PLANT NAME: H.B. Robinson # 2

RE: H. B. ROBINSON UNIT NO. 2
DOCKET NO. 50-261
FACILITY OPERATING LICENSE NO. DPR-23

Responses to Request for
Additional Information Transmitted by NRC
Letter of September 30, 1975

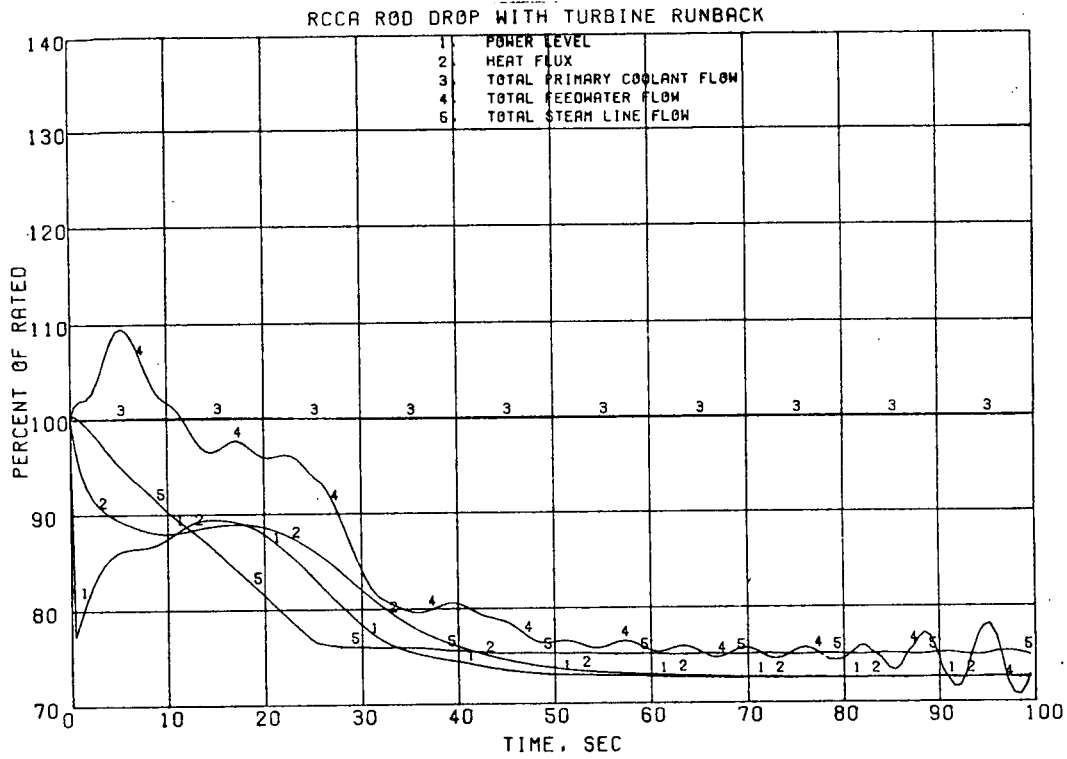
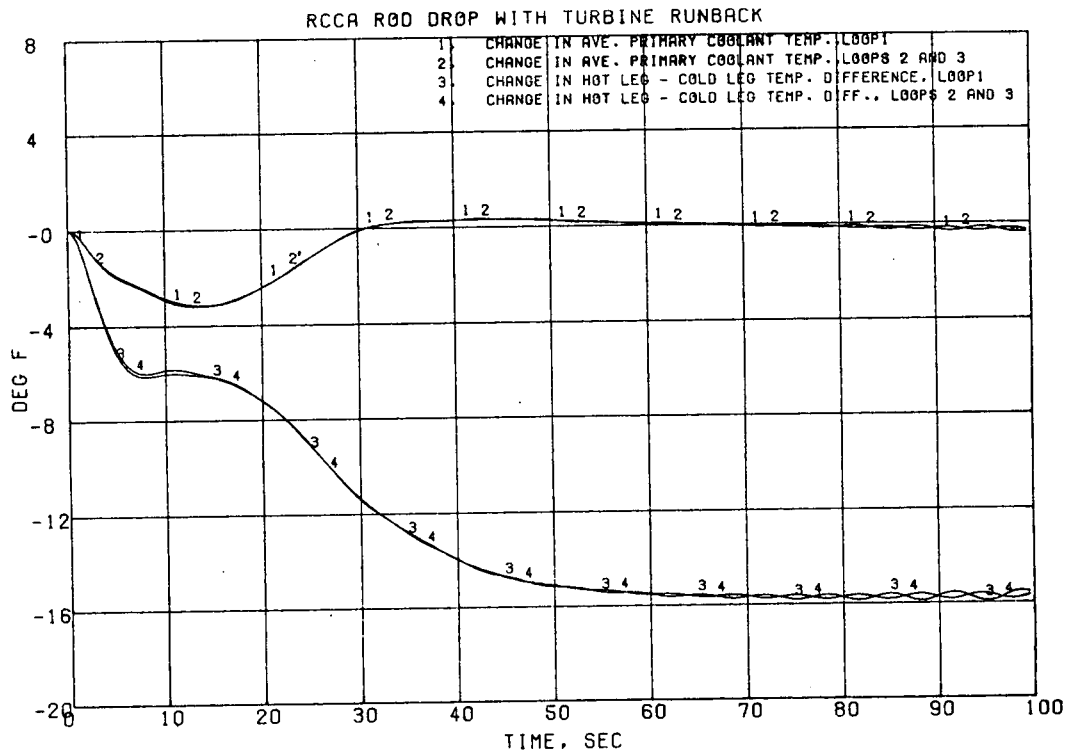
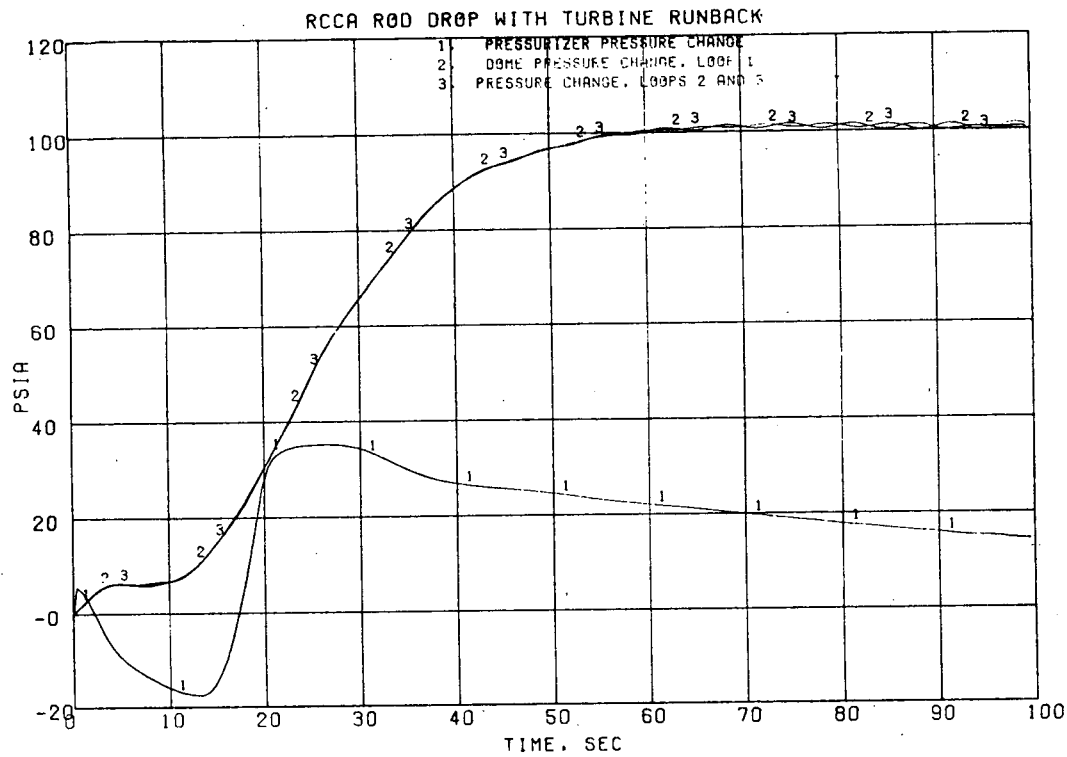
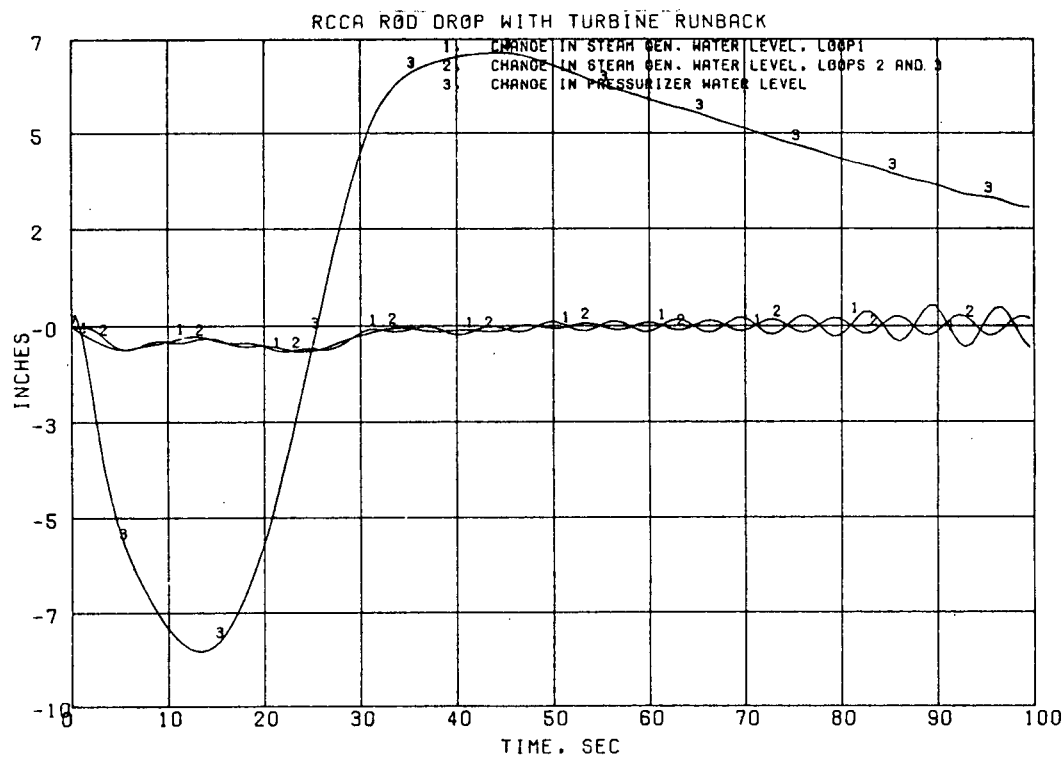
Provide an analysis of the consequences of the RCCA drop presented in Section 3.2 of XN-75-14 if automatic turbine cutback does not occur. Also, what happens if the system is under manual control, and control rods are withdrawn to maintain power?

The results of a transient analysis with both of the above actions occurring are depicted in Figures 1-1 through 1-4. The reactor does not return to power. The peak heat flux reaches 89% of rated, and MDNBR does not fall below its initial value.

GUIDE TUBE TO SPACER ATTACHMENT

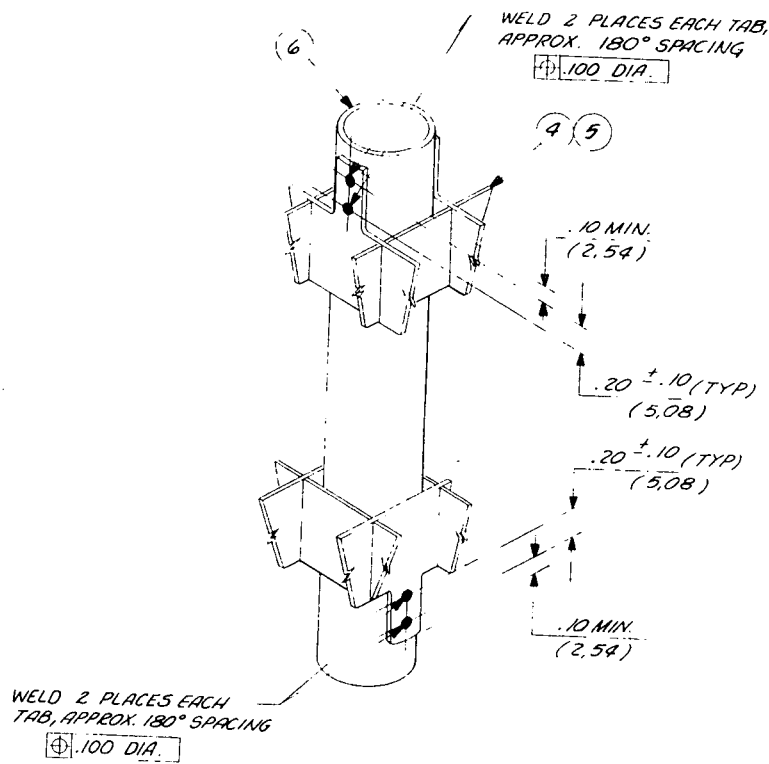
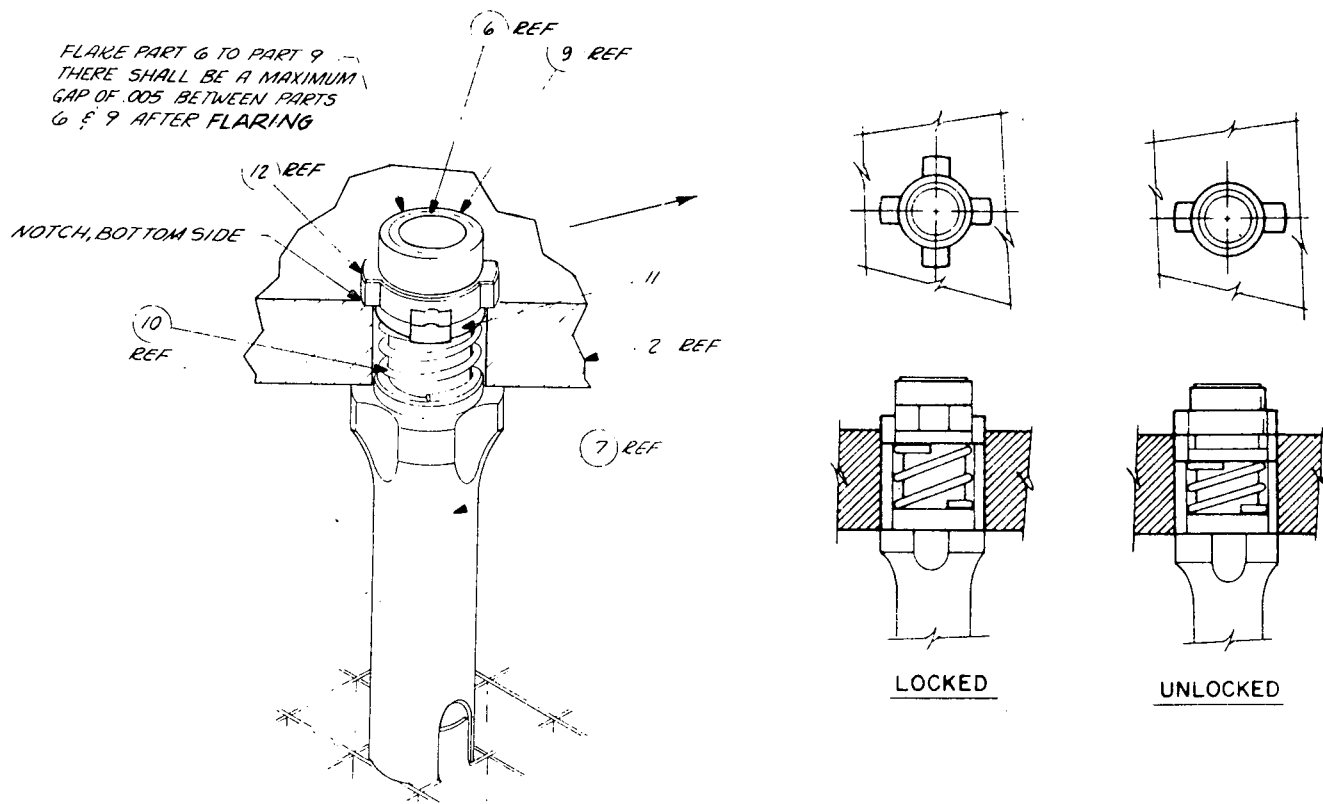
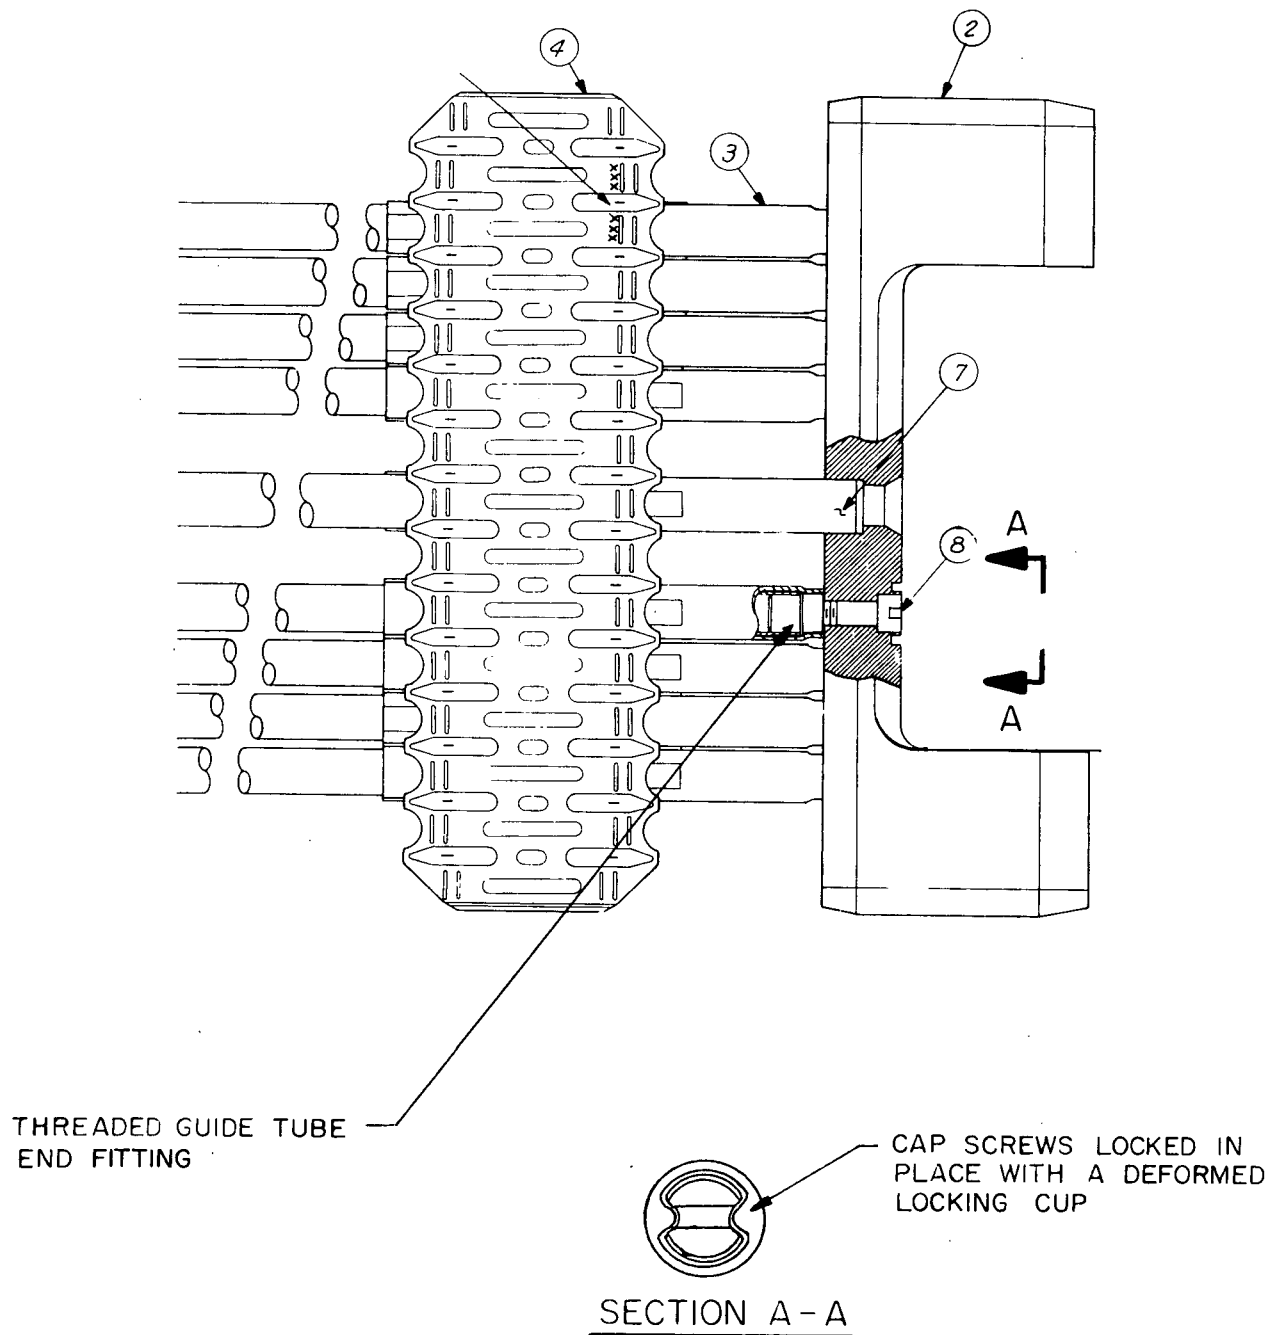
What method of attachment between the spacer grids and the guide tubes is used?

Provide a drawing which shows the method of attachment of the control rod guide tubes to the upper and lower grid plates and the method of attachment of the spacer grids to the control rod guide tubes. Describe any differences between the Exxon design and the Westinghouse assemblies currently in HBR in these areas.

Grid spacers are capacitance resistant welded to the guide tubes. Four weld tabs are provided on the spacer at each guide tube location. Details are shown in Figure 5-1.

Details of attachment of guide tubes to the upper tie plate, lower tie plate and grid spacers are shown in Figure 5-1.

Figure 9-1

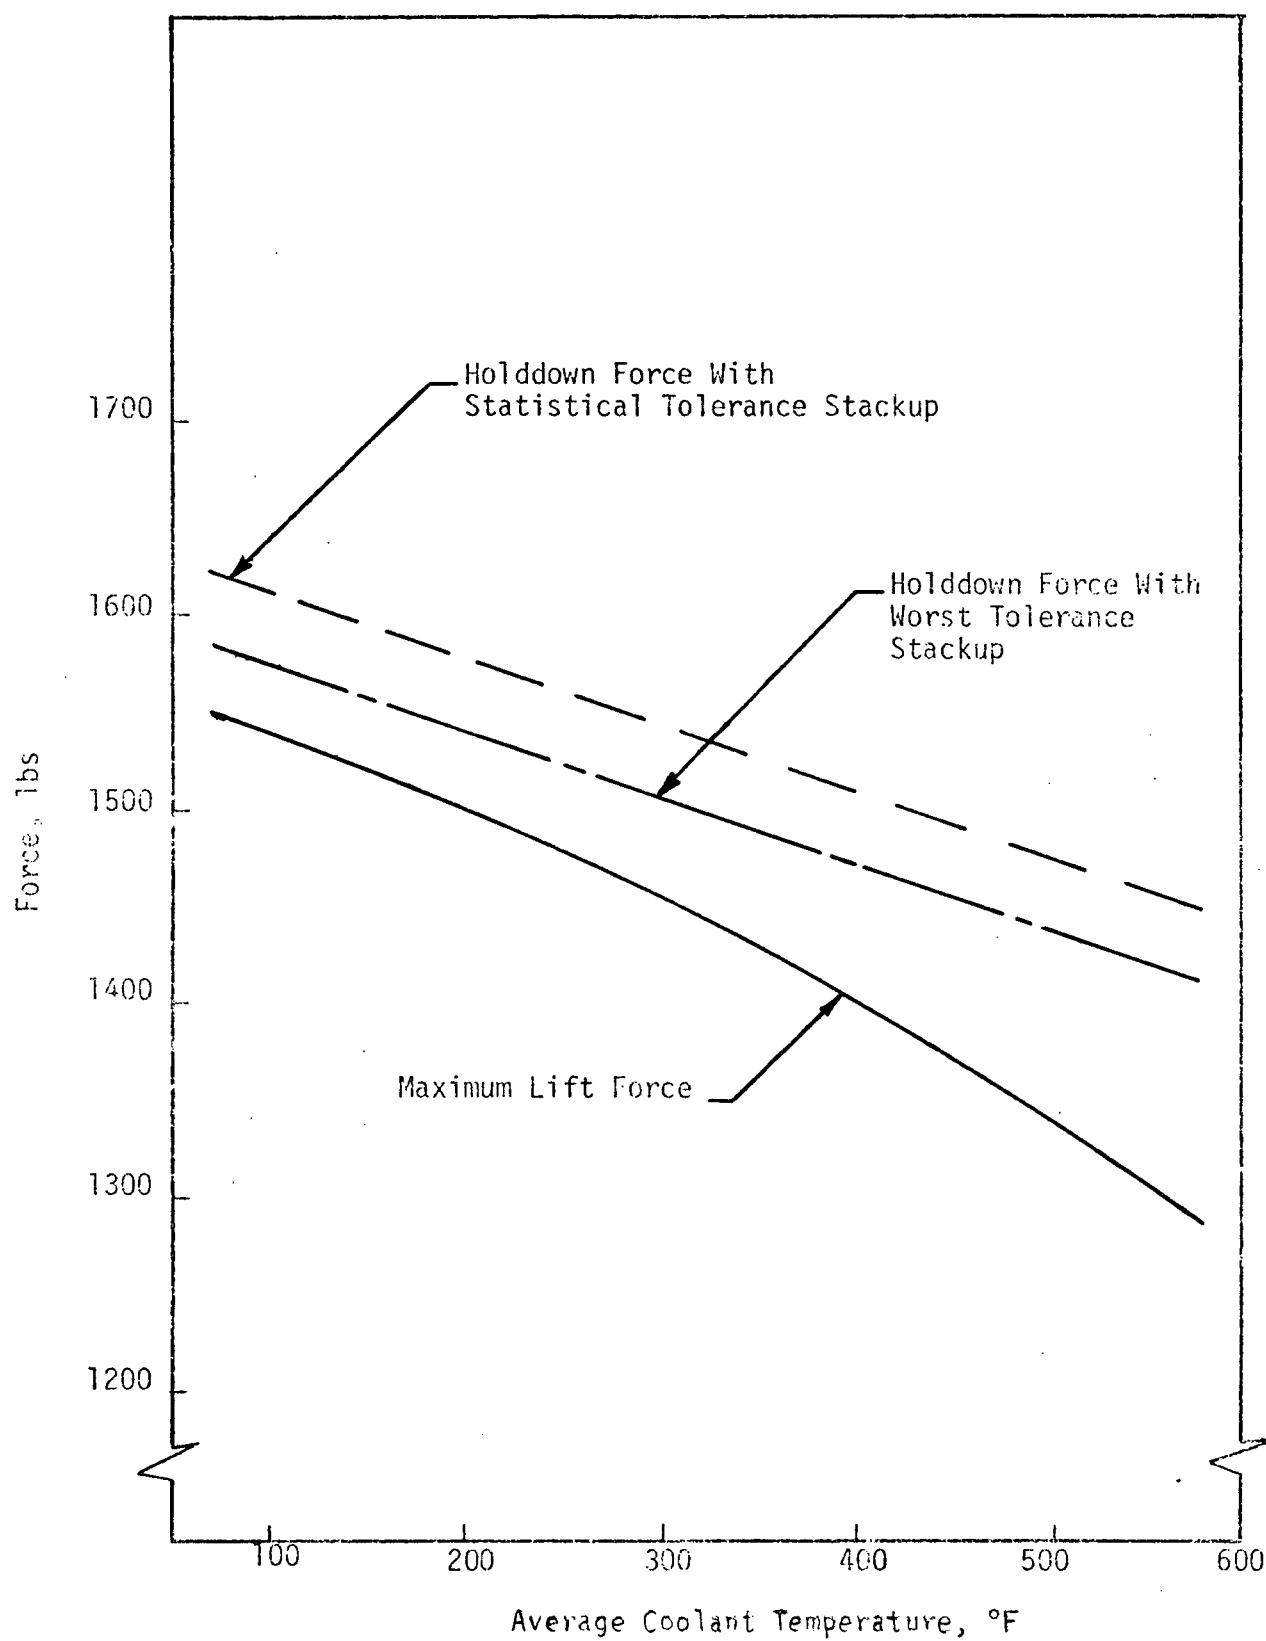
Provide an analysis or thermal hydraulic test data which shows the design adequacy of the holddown forces provided by the four leaf springs located in the upper grid plate in preventing fuel assembly liftoff.

The estimated lift force on the assembly, based upon ENC prototype ΔP tests and information furnished by the reactor supplier, is illustrated in Figure 9.1 and is a function of operating temperature.

Figure 9-1 shows the total holddown load (spring load plus immersed assembly weight) for the improbable case illustrated above where tolerances are stacked up in the most conservative way and also for the more probable case where the tolerances are stacked up on a statistical basis.
